**NSLPP MEETING HELD ON 07/12/2022
(SECTION 4.55 MODIFICATION)**

ADDRESS/WARD: 29 Churchill Crescent, Cammeray (T)

APPLICATION No: 386/09/4

PROPOSAL: To modify Development Consent DA 386/09 for a new dwelling – addition of retractable shade structures

Figure 1 : South Elevation

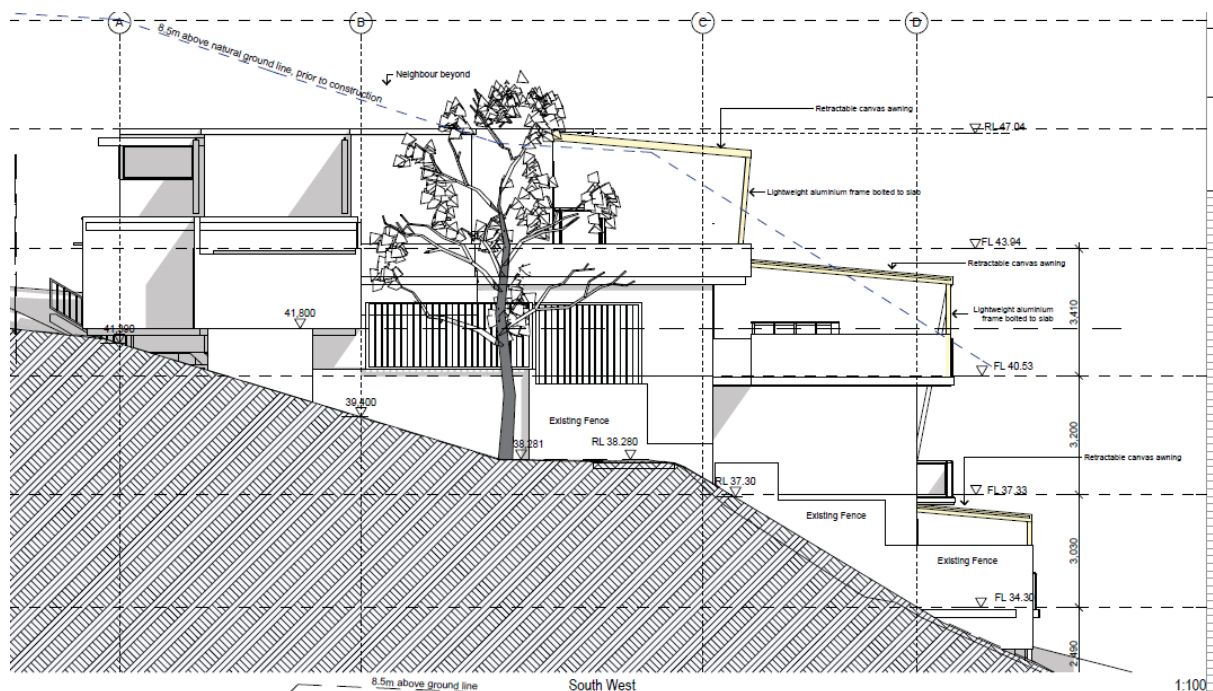
- to regularise the “as built” retractable awning structures located on the lower ground, ground and first floor terraces at the rear of the subject property.

The application essentially seeks to modify the consent by way of regularising the three installed pergolas with retractable canvas awnings.

Drawing Title:
Sunstudy - Winter Shadow Diagrams
 Winter Shadow 10am, Winter Sun at 11am, Midday Winter Sun, 2pm Winter Shadow, 3pm Winter Shadows, 9am Winter Shadows, 1pm Winter Shadows
 Date: 20.10.22

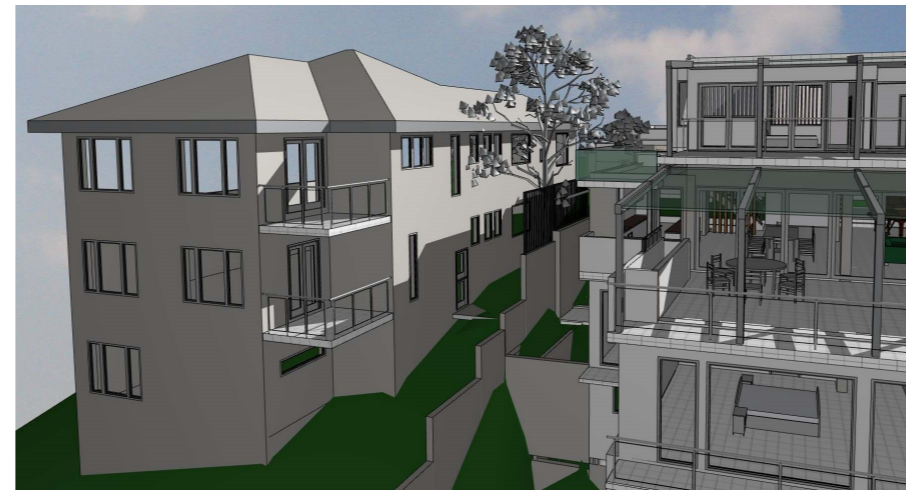
Shadow diagrams have been submitted which detail that the proposed modifications result in minor overshadowing to No.27 Churchill Street. The shadow diagrams demonstrate that both balconies within No.27 Churchill Crescent would receive at least 2 hours of sunlight between 9am and 11am. Whilst some additional overshadowing occurs prior to 12midday, at least 50% of each balcony would receive sunlight up until this time. As such, the proposed retained solar access to these balconies is considered to be acceptable, particularly given their location at the rear of the site, enjoying solar access across the side boundary. The key elements of the approved development within No.29 Churchill Crescent involving generous side setbacks to No.27 Churchill Crescent, are retained by the modified development.

It is noted that the shadow diagrams depict the retractable awnings in the retracted position. When open, the awnings would give rise to an unacceptable level of impact and a suitable condition will be applied requiring removal of the awnings to the southern pergola bays on the two uppermost levels.

A9. The southernmost bays of the pergolas serving the two upper most balconies are not approved and are to be removed or disabled from closing on a permanent basis.
